STAIRCRAFT
Group

Top Winder Newel Post Installation Guide

Staircraft have introduced a new detail at the top of winder flights to simplify stair installation

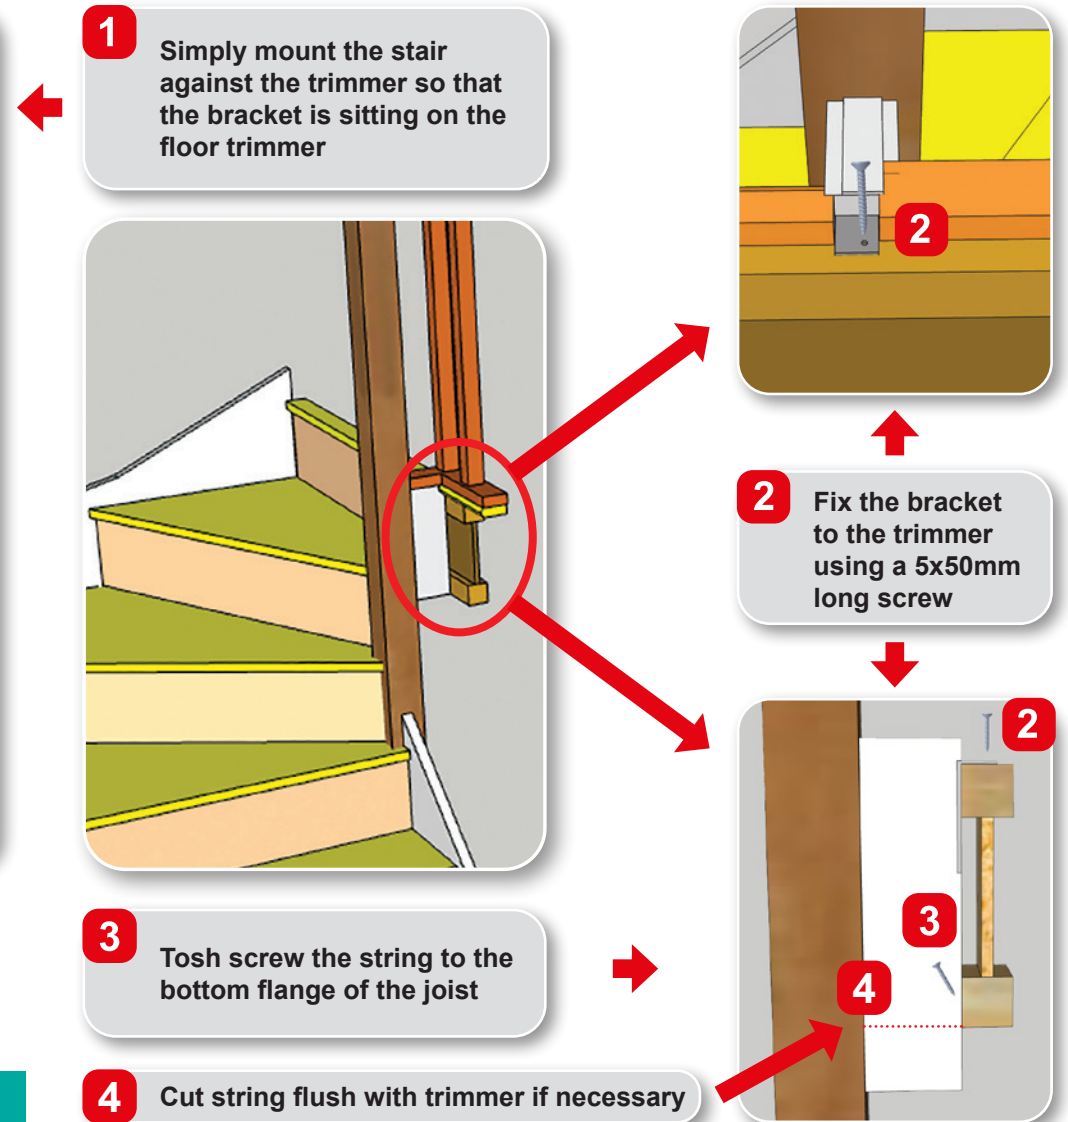
In the new detail, a factory fixed short string section is extended off the winder newel post with a bracket incorporated to attach directly onto the adjacent floor trimmer. The landing balustrade will then return through 90° into this newel post.

The new string section and bracket is factory fixed to the winder newel post, reducing the number of components necessary to fix on site, and speeding up assembly.
